FW: R3.0138.21 Interim Comments from OCC Highways

These comments are interim comments relating to the recent planning application R3.0138.21, also known as HIF1. They do not provide a recommendation at this stage, rather, they seek to clarify a number of technical issues and gather further details, prior to the final highways comments being provided by OCC in its capacity as the Local Highways Authority.

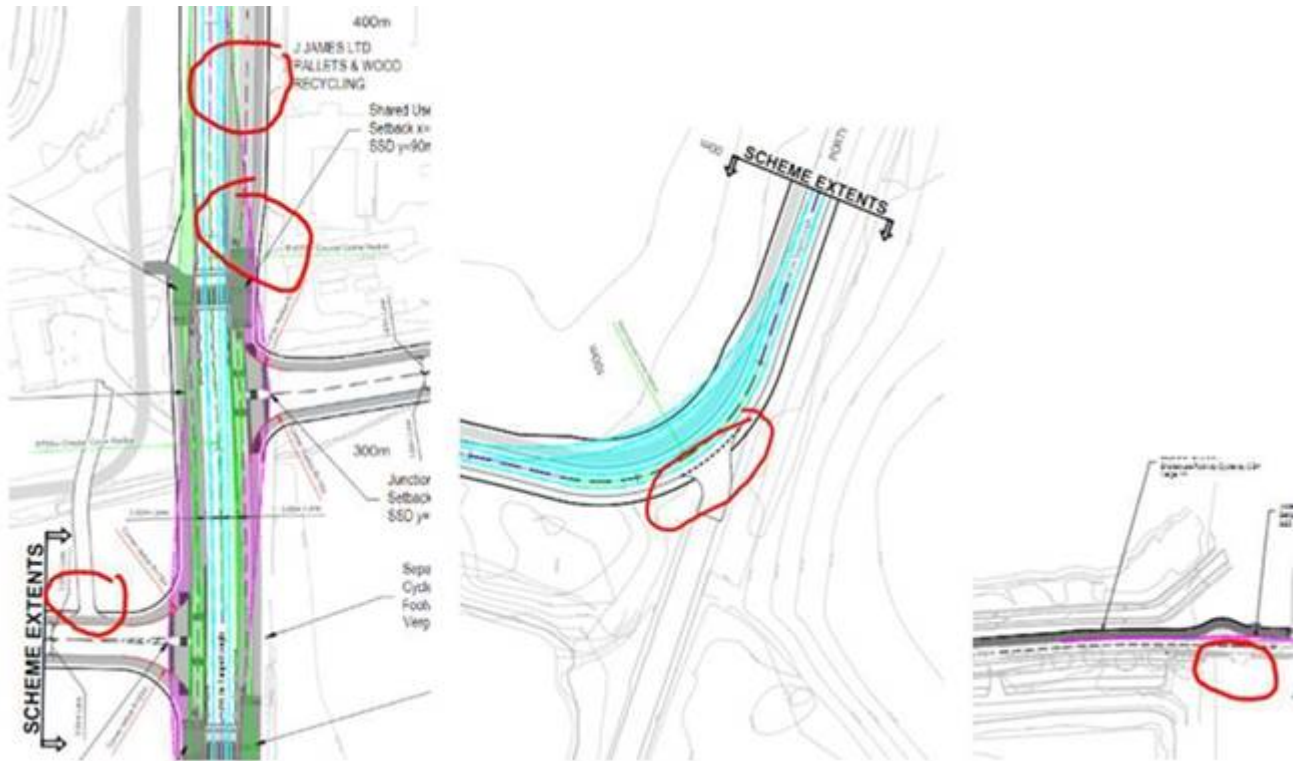
1. On GA plan 9, please clarify the speed limit and horizontal radii for the bend circled in blue below.

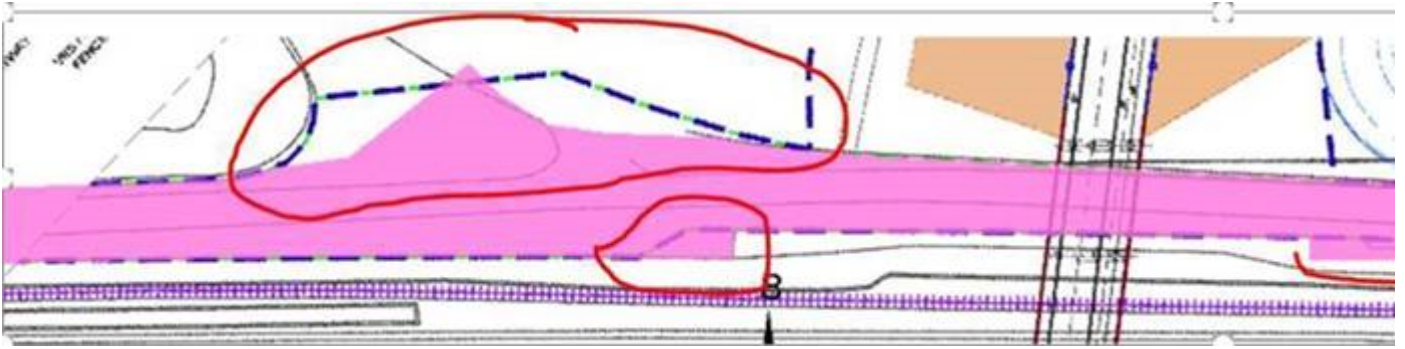
1. Provide in plans with separate colours for the vehicle tyre tracks and vehicle overhang swept path.
2. Provide a swept path of the largest coach available including overhang.
3. Please ensure the vehicle overhang does not conflict with any pedestrian and cycleway areas.
4. Where vehicles manoeuvre between central refuges etc. please ensure there is 0.5m tyre clearance on each side. This is particularly the case on GA plan 1 on the Backhill roundabout.

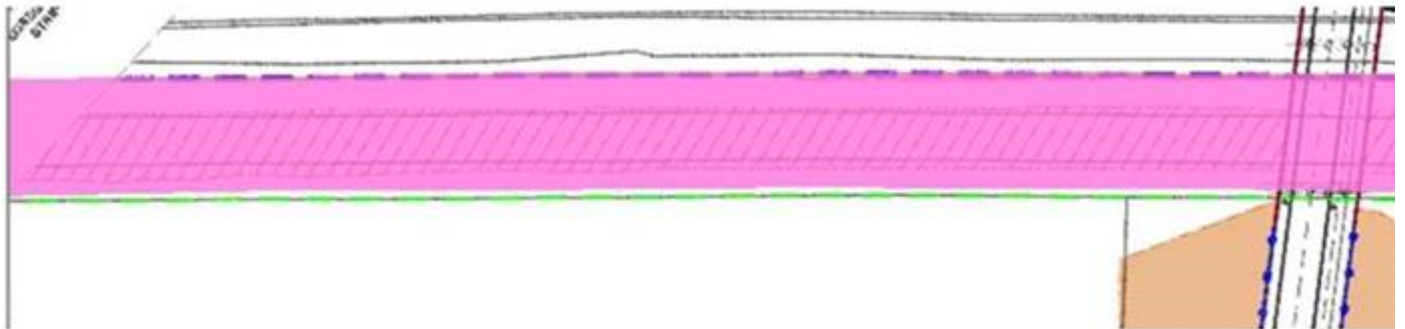
1. There are a few incorrect lines – mostly outside the scheme area though. Highway Records were using the 2007 base map, as it seems to fit the best, but still cannot get sheet 1 quite right.
2. There is no existing highway within the bounds of sheet 2.
3. The incorrect boundaries are
 - Various along Milton Road – confident with this section because the maps fit very well here (sheet 1):
